TO: Dr. Jesse Bacon, Superintendent
FROM: Danny Clemens, Director of Facilities
Date: June 16, 2025
RE: Phase II Athletics - **Change Order 26 - Bullitt East Site Revisions**

Change Order

PROJECT: *(Name and address)*
BCPS - Phase II Athletics - Bid Package
No. 1 - Baseball and Softball
Bullitt County, Kentucky

Change Order Request 59 - PCO #119 - RFP-18 BEHS Civil Revisions - REVISED

SOFTBALL FIELD

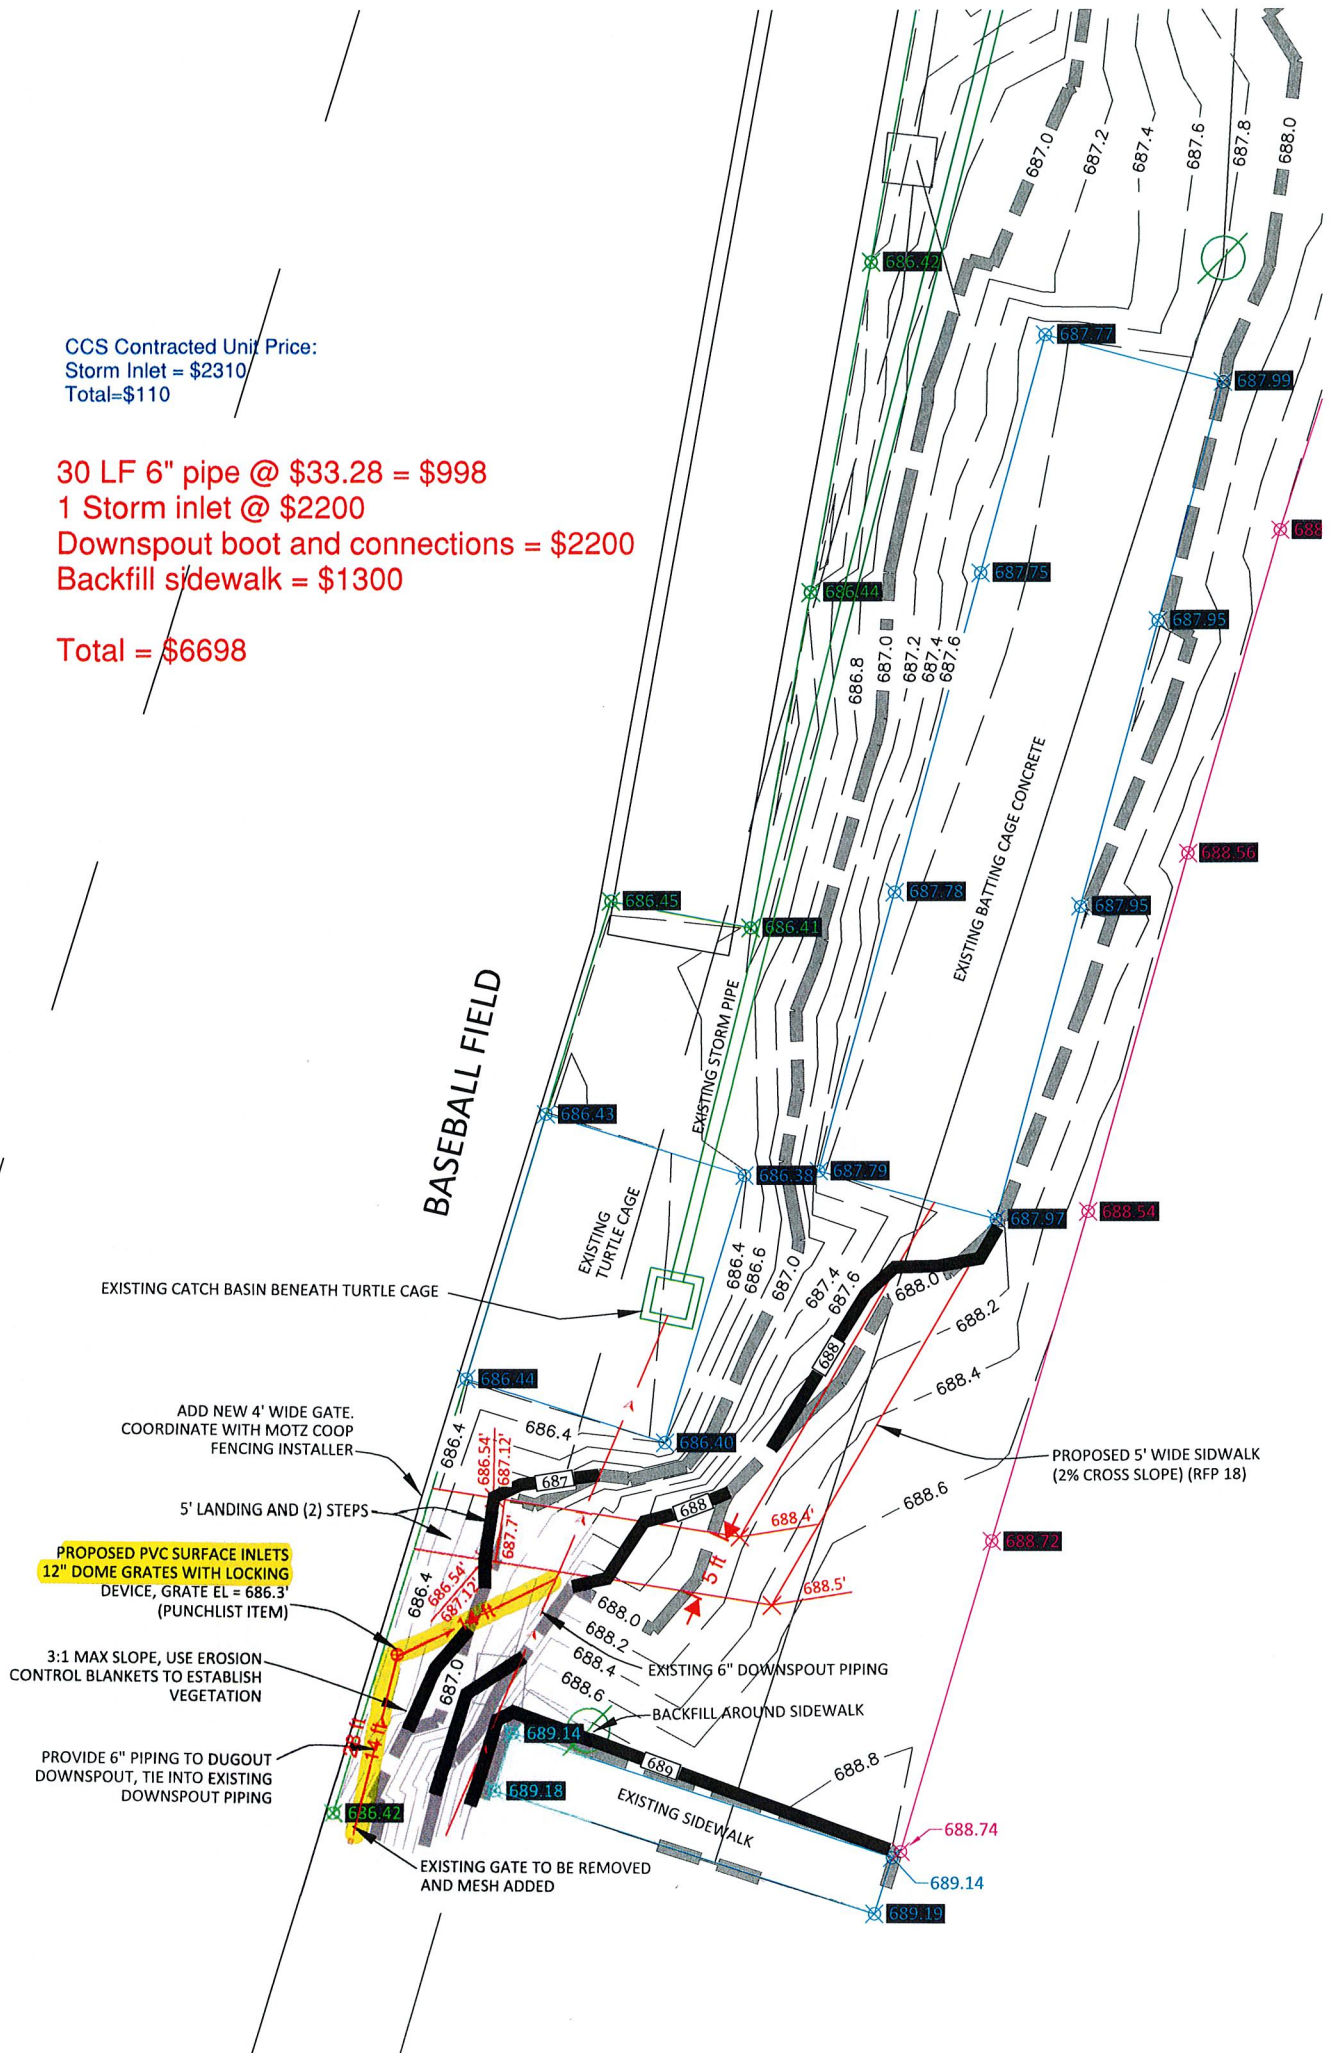
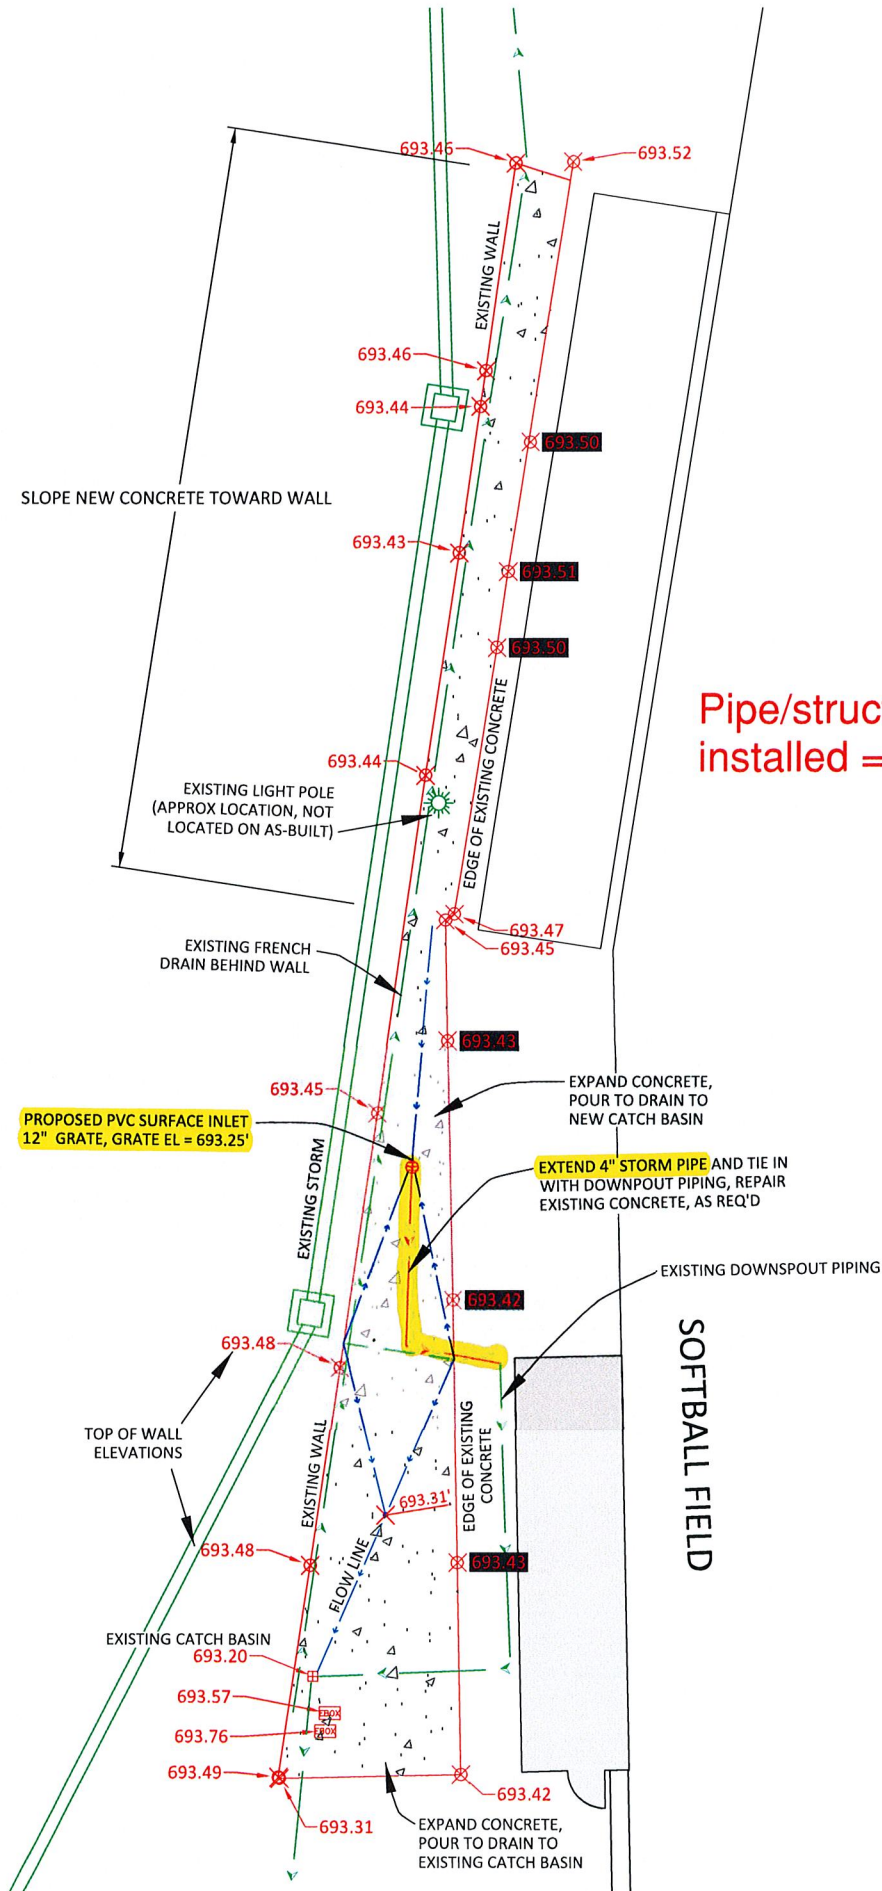
CCS Contracted Unit Price:
Storm Inlet = \$2310
Total=\$110

30 LF 6" pipe @ \$33.28 = \$998
1 Storm inlet @ \$2200
Downspout boot and connections = \$2200
Backfill sidewalk = \$1300

Total = \$6698

Pipe/structures
installed = \$2100
